May 3, 2005

ITEM NO. 9

Subject: Lake Cuyamaca Parks and Recreation District Septic System Status and Proposed Action (Order No. R9-2004-0015)

Monitoring Well 1 Chloride and Sulfates

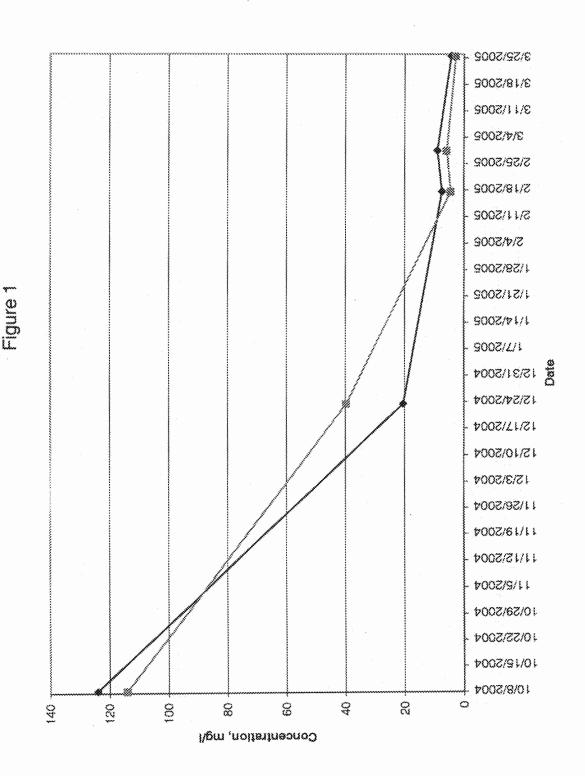
The Kennedy/Jenks report states that the Cedar forest fire could be the cause for the high levels of nitrates and iron. However, no data are available to compare these values for comparable rainfalls and at pre-fire conditions. Nor does the report acknowledge that fires will occur in the future potentially causing similar impacts to the water quality. The report opines that the high chloride levels observed in the initial samples could be due to the chlorides leaching from the PVC (polyvinyl chloride) casing. See the attached Figure 1. However, the report fails to note the correlation with sulfates. Our analysis of the monitoring data shows a high degree of correlation between chloride and sulfate at well MW1. Was the wellhead capped per design standards to prevent surface flow contamination? See the attached Figure 1. The report apparently did not analyze this. Furthermore, if leaching is the reason, it begs the question why PVC pipe was used for water quality measurements and not HDPE (high density polyethylene) pipes that do not contain chlorides. The report did not state if percolation tests were conducted during and after the construction of the leach fields to determine the hydraulic conductivity of the subsurface. This information would have been useful in analyzing the monitoring well data.

Section 4 of the Kennedy/Jenks report indicates that the monitoring well data shows a declining trend in nitrates and iron concentration and may eventually meet the performance compliance. This reasoning assumes that future higher than normal rainfall even in the absence of forest fires would not cause non-compliance. We reject this line of reasoning. We also do not concur with the nitrate compliance alternatives.
